RE: **Jefferson Hotel**
Restaurant Ln NE
Grading Plan Stamp Date: 8/15/18
Drainage Report Stamp Date: 8/15/18
Drainage File: F17D044C

Based on the submittal received on 8/16/18, the grading plan and drainage report cannot be approved for building permit until the following are corrected:

RE: **Jefferson Hotel**
Restaurant Ln NE
Grading Plan Stamp Date: 7/30/18
Drainage Report Stamp Date: 7/30/18
Drainage File: F17D044C

Based on the submittal received on 7/31/18, the grading plan and drainage report cannot be approved for building permit until the following are corrected:

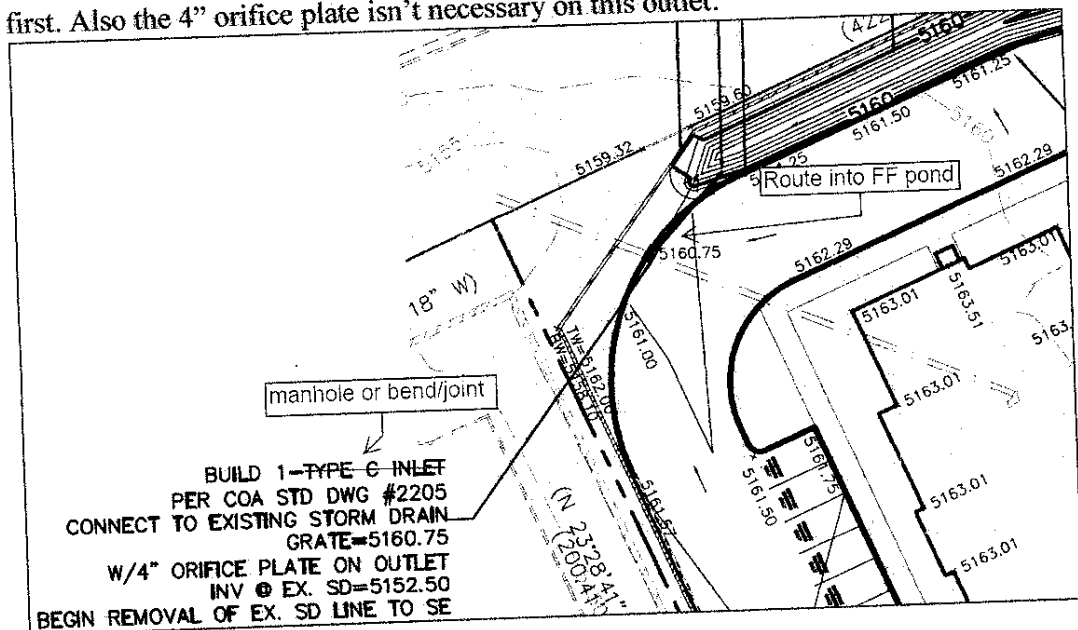
1. The Type C inlet at the NW corner should be removed as it allows surface flows to bypass the first flush pond. Stormwater draining to this low spot will need to be routed to the pond first. Also the 4" orifice plate isn't necessary on this outlet:

CORRECTED
